Our Ref: 23-1045
Your Ref: MCUC 2023_5563

RE: RESPONSE TO COUNCIL'S INFORMATION REQUEST ASSOCIATED WITH A MATERIAL CHANGE OF USE (DWELLING HOUSE) AT 12 MURPHY STREET PORT DOUGLAS.

**RFI CIVIL RESPONSE SUBMISSION
MCU - DWELLING HOUSES MCUC 2023_5563
12 MURPHY STREET, PORT DOUGLAS (L113 PTD2094)**

PROJECT
12 MURPHY STREET RESIDENCE
LOT 113 PTD2094 MURPHY STREET
TITLE
DRIVEWAY CL01 - PLAN

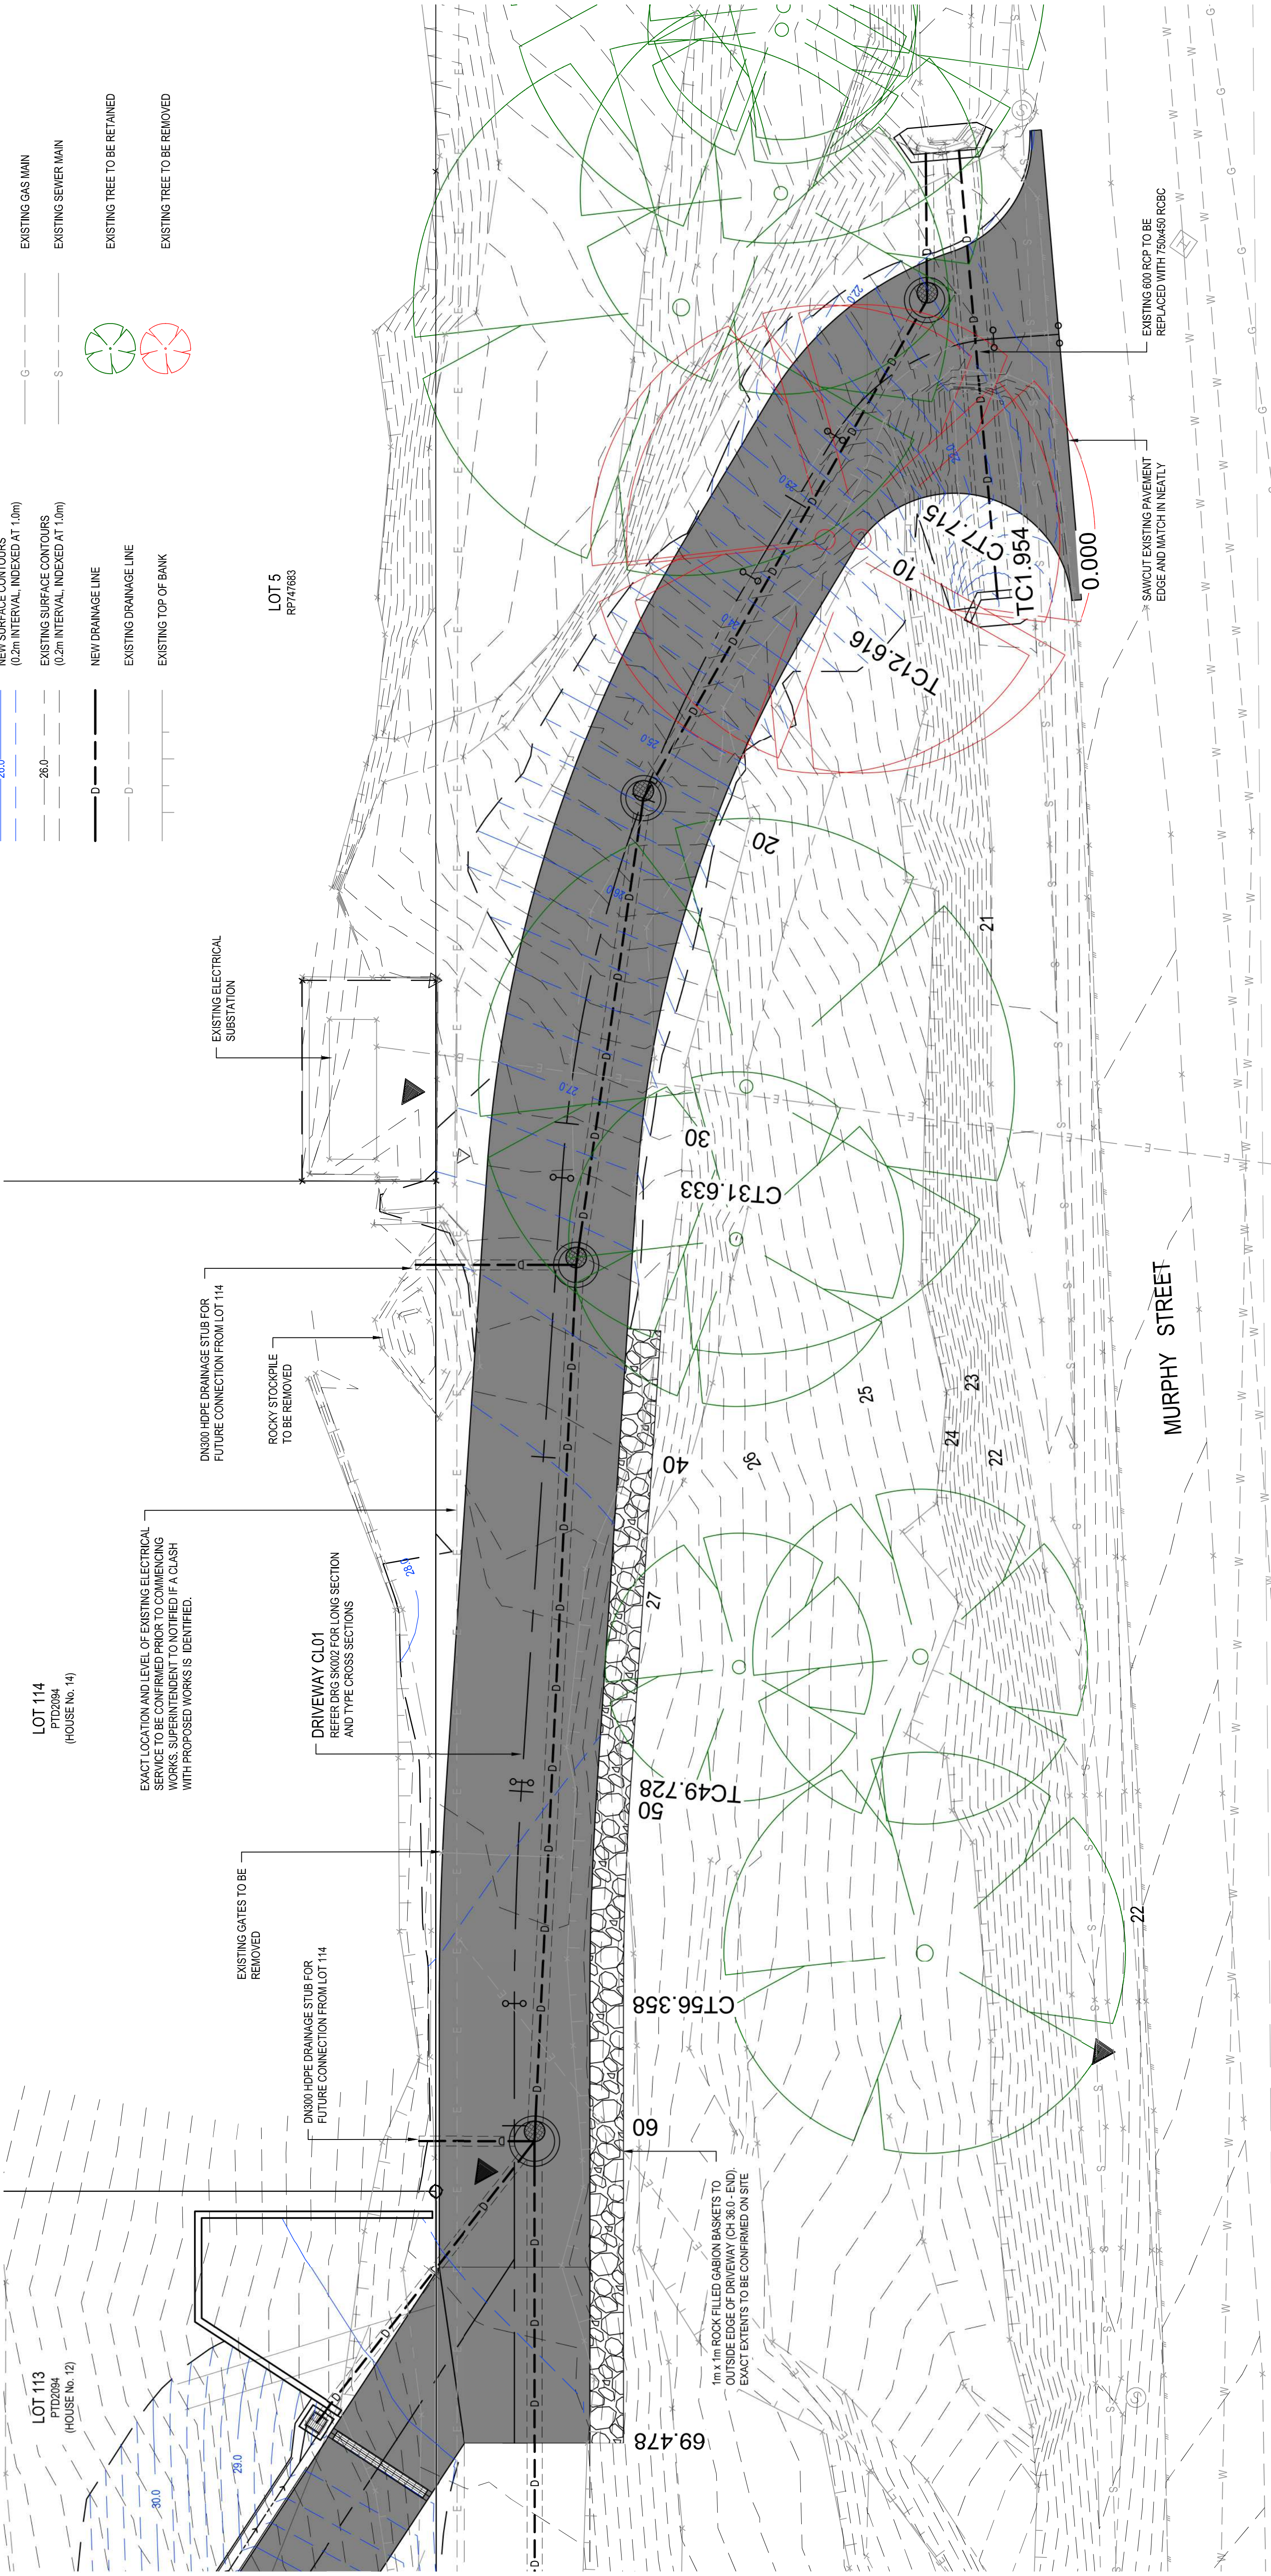
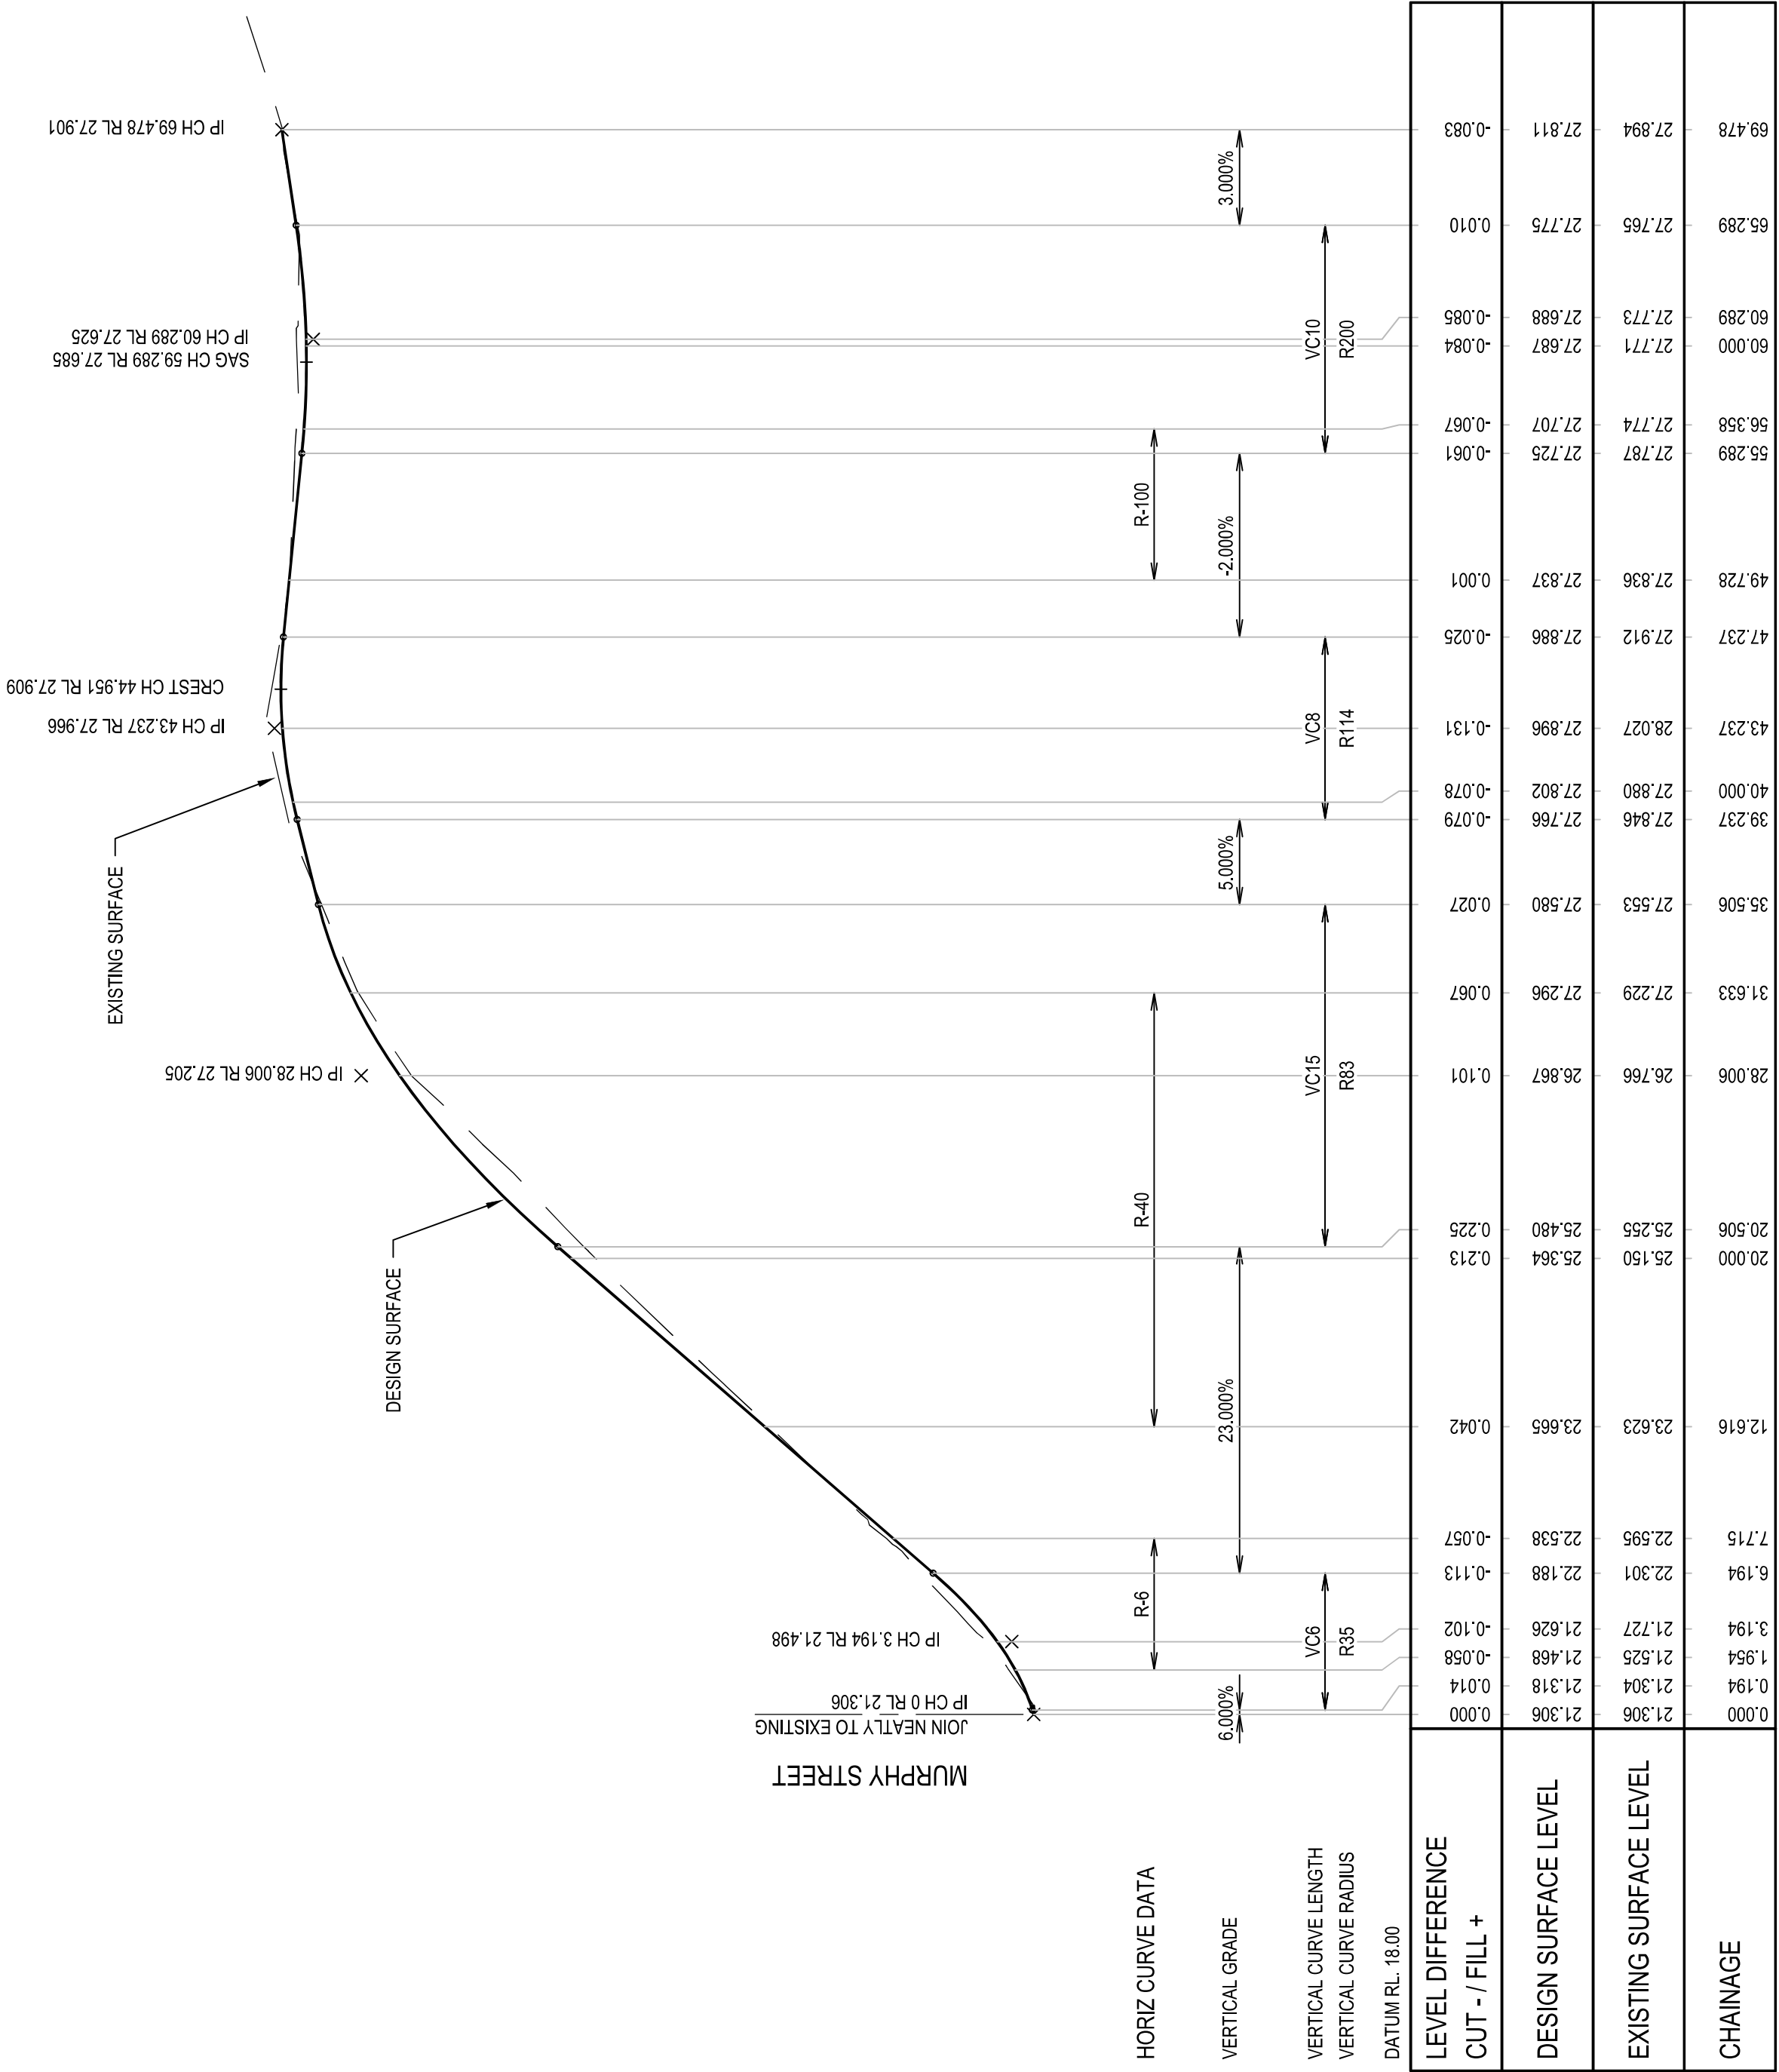
2. *Confirm the proposed width of the sealed access within the Murphy Street Road reserve.
Officers note a 2.6m wide access is proposed on Balay Vandyke Drawing 7 of 14 (Site Plan - Revision F) for the frontage of the subject site.
The application material does not demonstrate how access will be provided to Murphy Street sealed road formation. This lower section services 10, 12 and 14 Murphy Street.
Concern is raised regarding the ability for vehicles using the shared access to safely pass one another at low speed without departing from the road. Reference is made to Complete Streets Table 6-2 for minimum widths for passing vehicles.*

4. *Concern is raised regarding the requirement for a 1.8m retaining wall proposed in the Murphy Street road reserve shown on Balay Vandyke Drawing 7 of 14 (Site Plan- Revision F). Note, the proposed retaining wall also appears to be located near the top of an existing steep batter which may have stability implications for the road reserve. Note that a retaining wall in road reserve of this height is considered to be an unacceptable solution.*
Clarify the justification for raising the level of the shared access external to the site within the Murphy Street road reserve. Options to minimise the level change in Murphy Street are to be considered.
Provide a cross section through the proposed 1.8m retaining structure through to and including the Murphy Street road formation.
Advice Note: The contour information shown on the Site Plan appears to indicate the extent of the design creates a large flat driveway section within the site (adjacent the garage). The absence of grade transition in this area appear to reduce the length available for the driveway grading and appears to dictate the level at the interface with the shared access at Murphy Street (to achieve the proposed 1 in 4 gradient).

Revised engineering sketch plans, which are similar to the previously approved Operational Works plans by Edge Consulting Engineers, have been created and modelled in 12D and a copy of these sketch plans is included in **Appendix A**.

The proposed shared driveway width is now 4.5m to reduce the footprint and ensure minimal impact to the existing trees by following the existing track alignment.

Table 6.2 of Complete Streets notes a 4.5m carriageway width is adequate for a 2-way shared street at 20km/hr with minimum service vehicles. This proposed driveway has a lesser function and speed environment than a shared street and given the proposed driveway will only service, at the most 4 but more likely 3, residential allotments with both lots 12 and 14 having the ability to enter the shared driveway in a forward manner and to stop at the bottom of their driveways and see any other vehicle on the driveway, a 4.5m shared driveway is of adequate width.

The proposed driveway has been regraded slightly to negate the need for any retaining within the road reserve. Sketch plans of the driveway with a long section and cross sections are included in **Appendices A and B**.

LONGITUDINAL SECTION - DRIVEWAY CL01

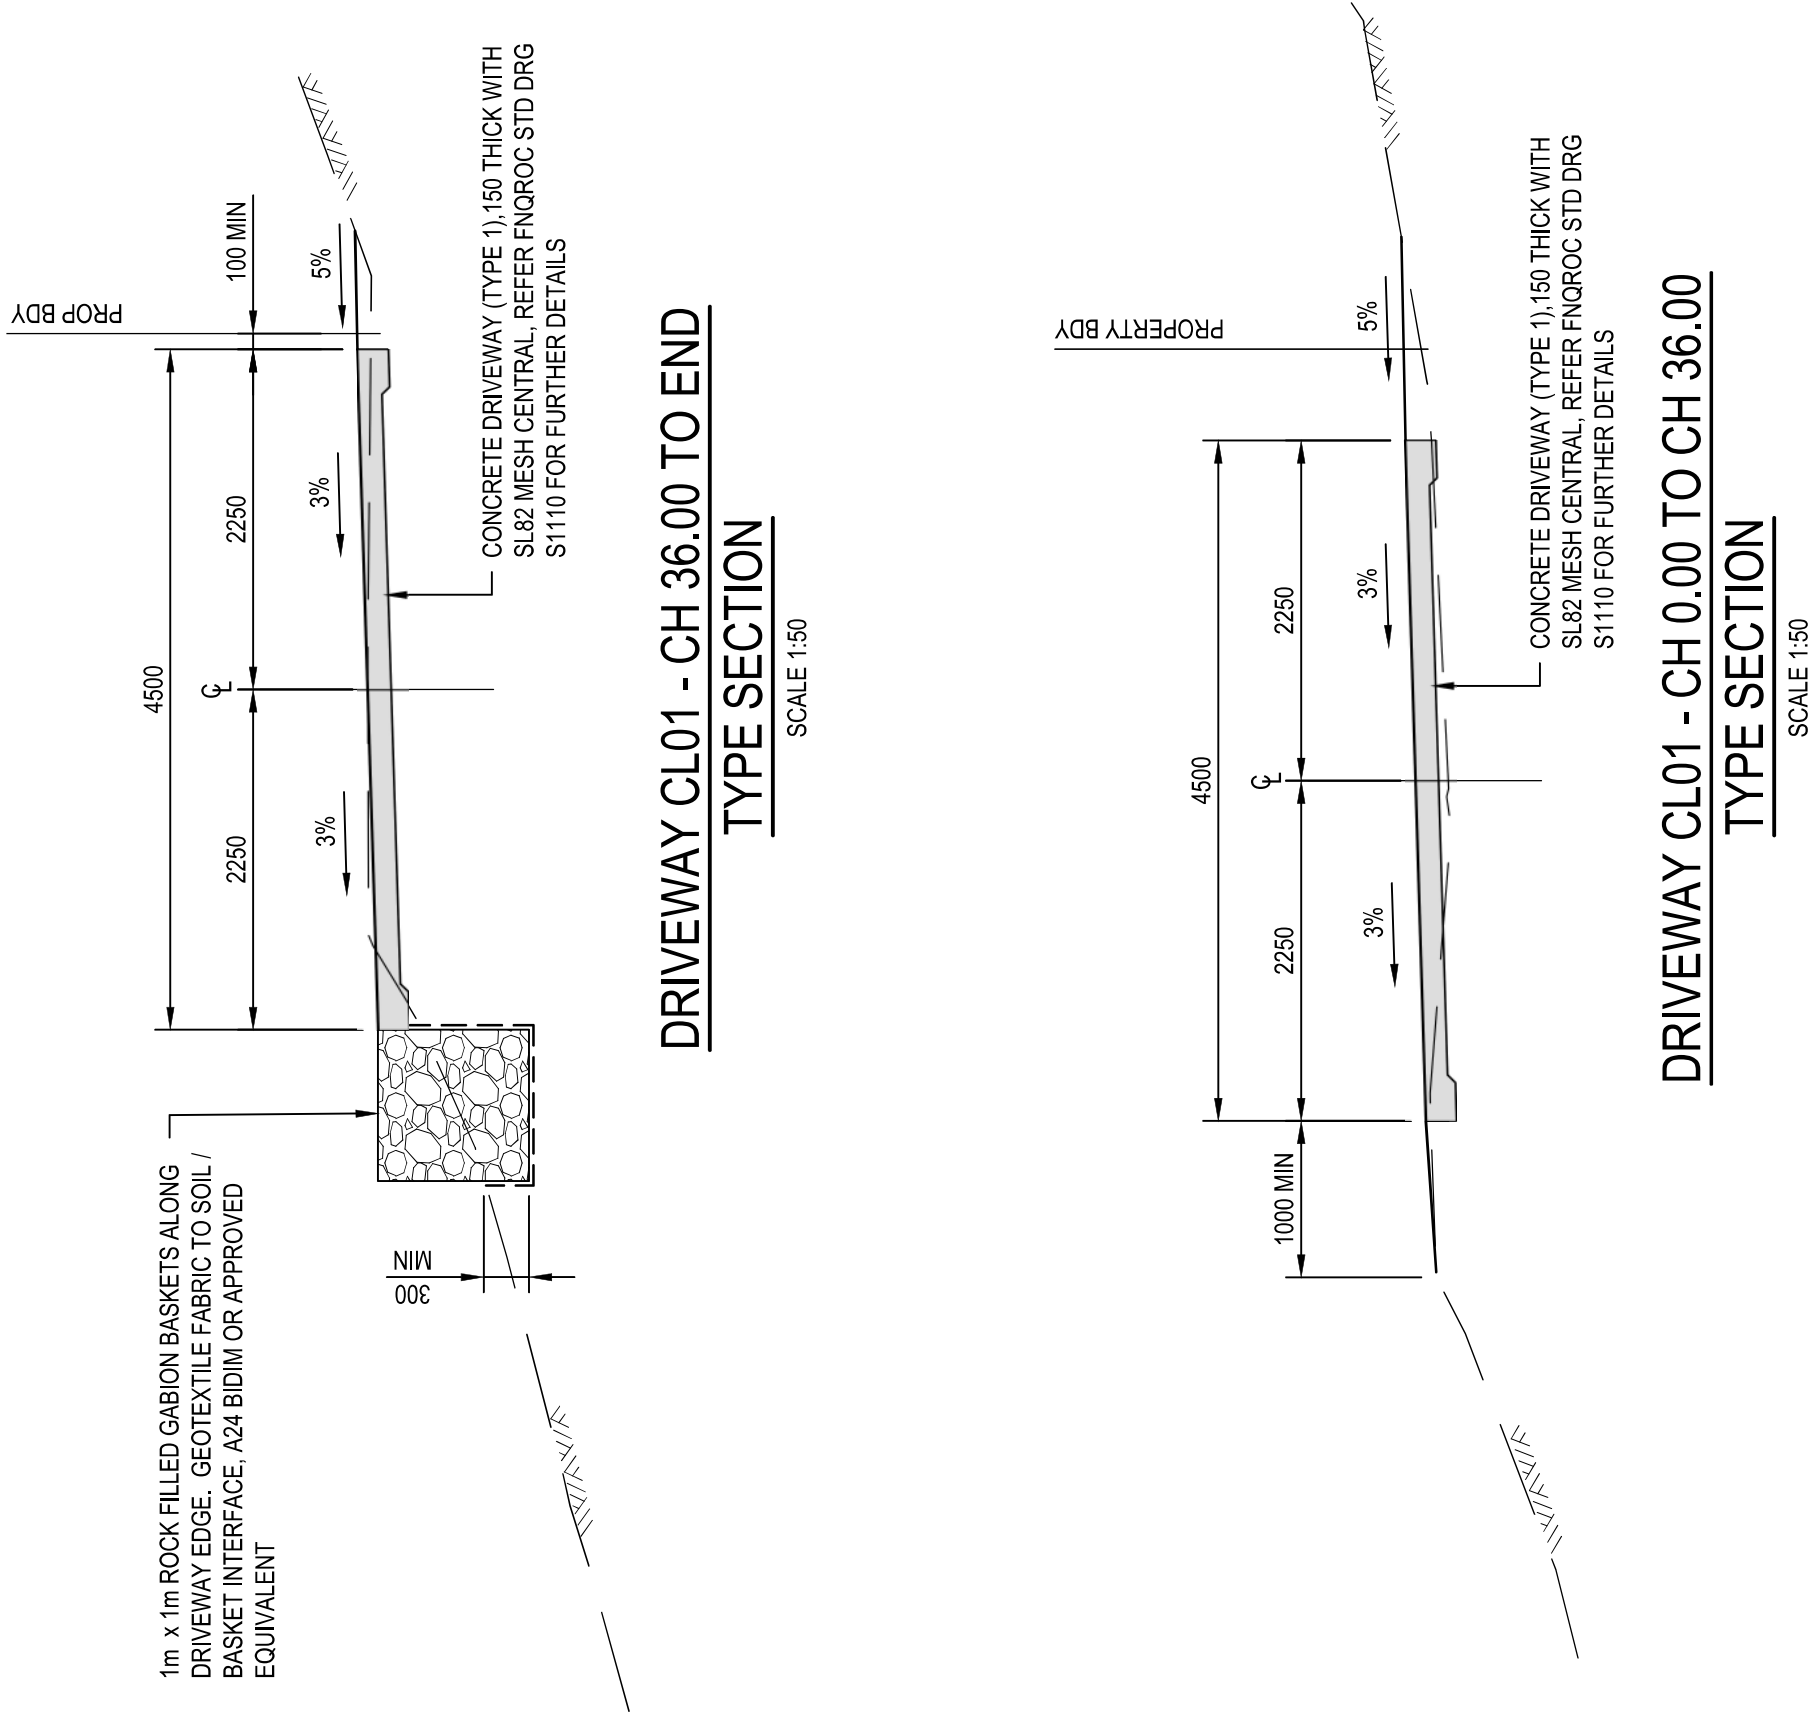
6. *Provide further information in the form of longitudinal and cross sections indicating the cut and fill required to construct the shared access in Murphy Street, and the internal driveway.*

Refer sketches provided in **Appendix B**.
